UNITED STATES PATENT AND TRADEMARK OFFICE

APPLICATION NO.	FILING DATE	FIRST NAMED INVENTOR	ATTORNEY DOCKET NO.	CONFIRMATION NO.
09/886,534	06/20/2001	Nam Mo Ku	ORIEN20.001AUS	6396

Office Action Summary

DETAILED ACTION

• Fig. 2

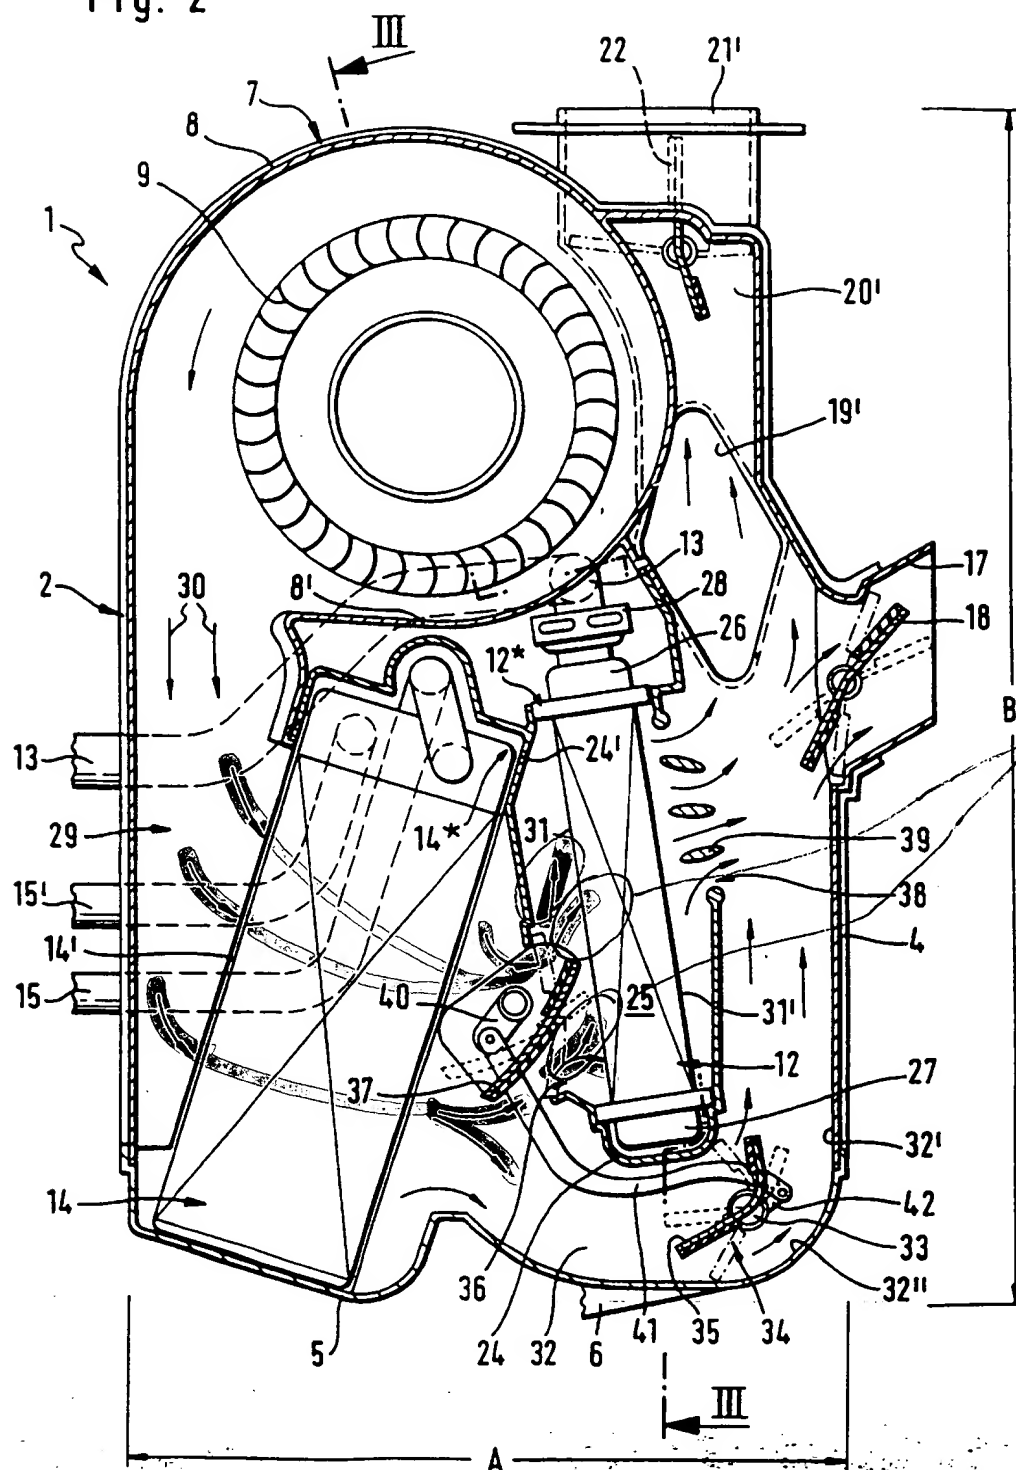
Applicant argues that “the reference fails to teach or disclose each and every element of the rejected claims, especially ‘a second direction substantially perpendicular to the first direction’.” Contrary to applicant’s assertion, however, *Bendell* indeed does disclose “the second chamber configured to pass a second air flow through the second heat exchanger in a second direction substantially perpendicular to the first direction” as shown via the flow arrows in Figure 2 of *Bendell*. See Attachment A to this Office action for a clarifying mark-up. Applicant’s marked-up “air flow directions” as presented in Exhibit A are not merely an inaccurate oversimplification of the airflow through the *Bendell* apparatus, but furthermore simply ignore the airflow arrows clearly shown in Figure 2 of the *Bendell* reference.

Bendell [especially Figure 2] discloses a vehicular air conditioner 1 essentially as claimed, including, for example: a housing 2 containing three chambers; a first heat exchanger 14 located in the first chamber, wherein the first chamber is configured to pass a first air flow through the first heat exchanger 14 in a first direction as shown by the solid arrows corresponding thereto; a second heat exchanger 12 located in the second chamber, wherein the second chamber is configured to pass a second air flow through the second heat exchanger 12 in a second direction substantially perpendicular to the first direction as shown by at least some the solid arrows

corresponding thereto; a third chamber configured to receive the heat exchanged air from at least one of the first and second chambers and to discharge the same from the air conditioner; a partition member corresponding to inner housing 24 having at least one arcuately curved surface and defining two openings corresponding respectively to the inlet opening 36 between the first and second chambers and to, for example, the inlet of duct passage 32 between the first and third chambers, the partition member or inner housing 24 together with the walls of the housing or casing 2 defining the three chambers, at least a pair of "side" passages configured to allow communication between the second chamber and the third chamber, this pair of "side" passages corresponding to any two of the passages between air-directing elements 39 disposed in the air outlet 39 from the second chamber on the upper side of the second heat exchanger 12 (i.e., hence the passages being "side" passages as broadly interpreted as required); a mix door readable on the combination of control flap 37 as connected to flap body 35 via linkage 41, this combination mix door being thus configured to adjust the degree of opening of both of the first and second openings defined by the partition member or inner housing 24, the door having an arcuately curved surface constituting the arcuate surface of control flap 37, this arcuately curved surface of control flap 37 in turn corresponding to the curved surface of partition member or inner housing 24 at the air inlet opening 36 [see phantom representation of the door or control flap 37 in the closed position as shown in Figure 2]; and, a conduit or connection tube 13 connected to the second heat exchanger 12 through a hole in the wall of the casing or housing 2 defined by the second chamber as shown in Figure 2. Also see Attachment A to this Office action.

at least
these
airflows
are
substantially
perpendicular
to the ones
through
the first
heat
exchanger
14
